Shasta Lake Water Resources Investigation Sept. 2008 Administrative Draft EIS

October 2, 2008

Thermal Mortality Rate for Winter-run Chinook Salmon Eggs while in the Redd using the 1999 - 2006 Population Average

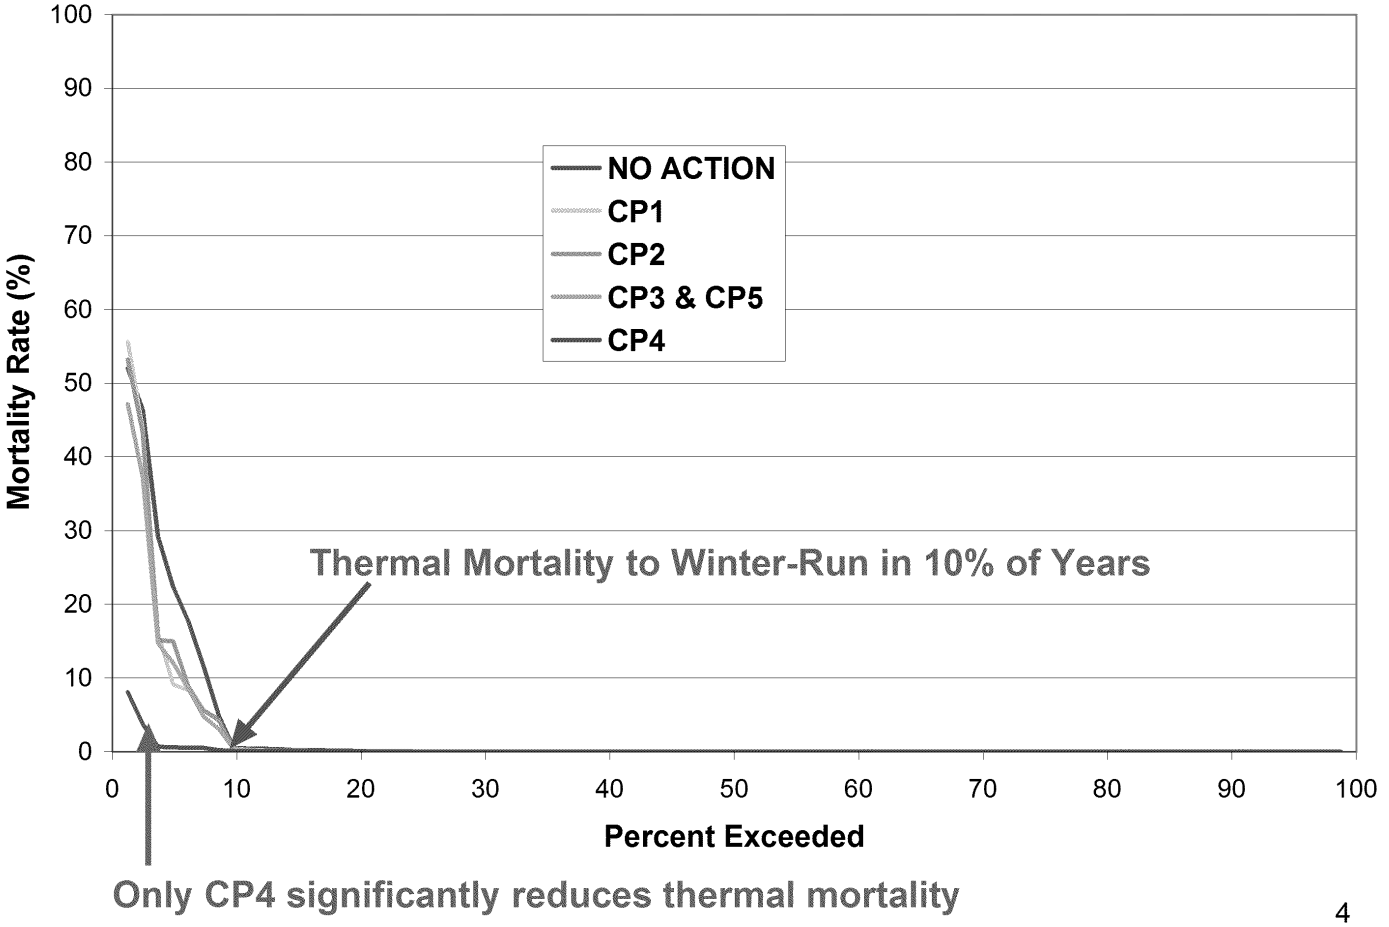
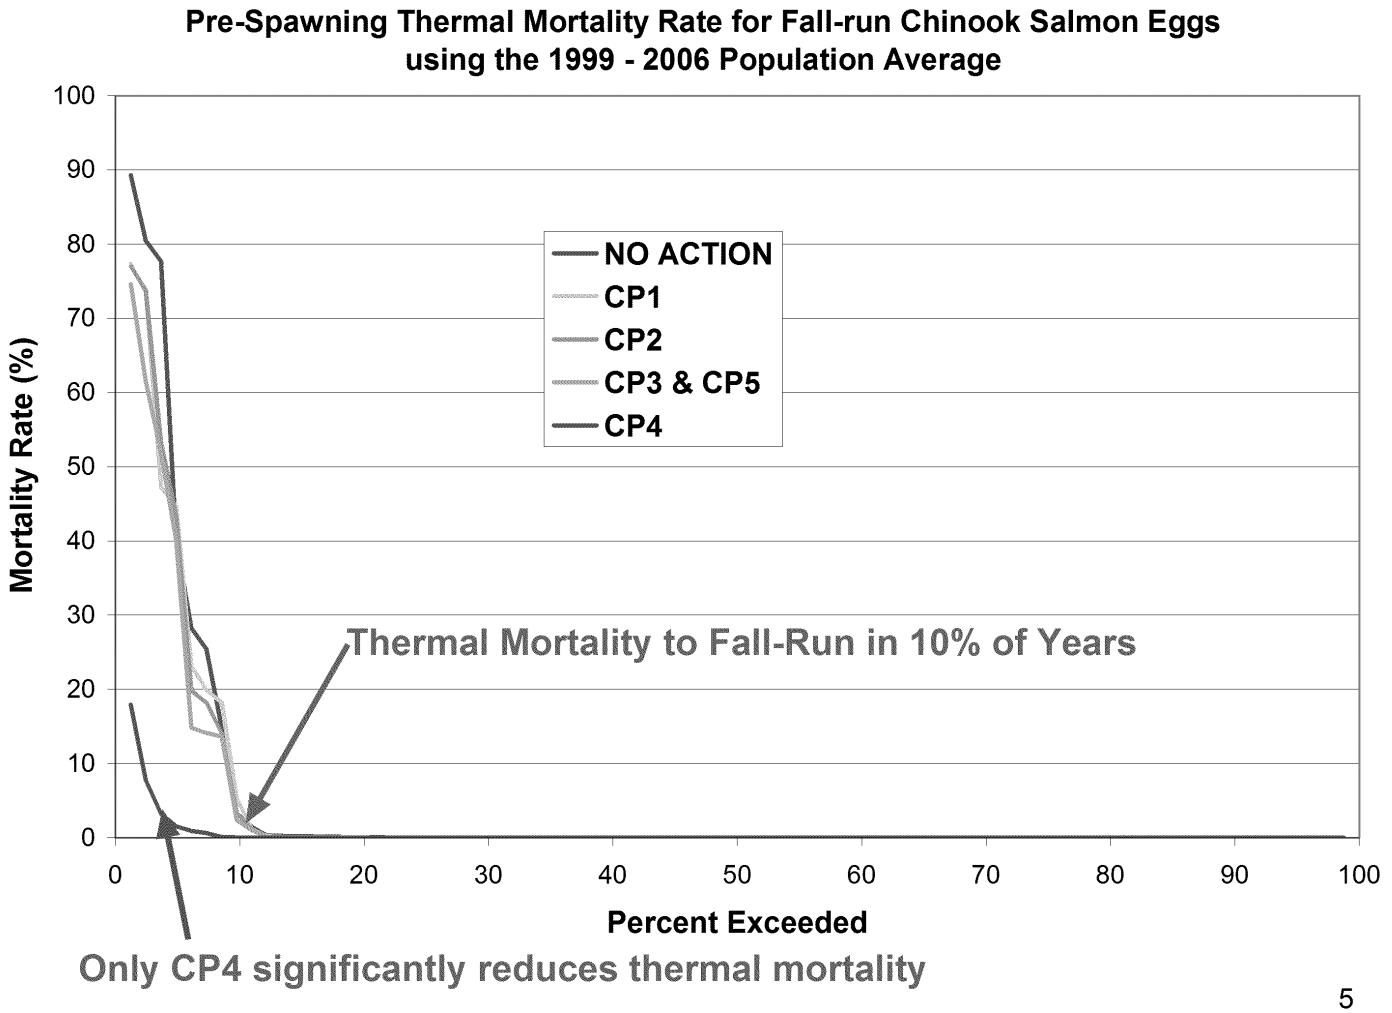
Pre-Spawning Thermal Mortality Rate for Fall-run Chinook Salmon Eggs
using the 1999 - 2006 Population Average
Mortality Rate (%)
100
90
80
70
60
50
40
30
20
10
0
0
10
20
30
40
50
60
70
80
90
100
Percent Exceeded
NO ACTION
CP1
CP2
CP3 & CP5
CP4
Thermal Mortality to Fall-Run in 10% of Years
Only CP4 significantly reduces thermal mortality
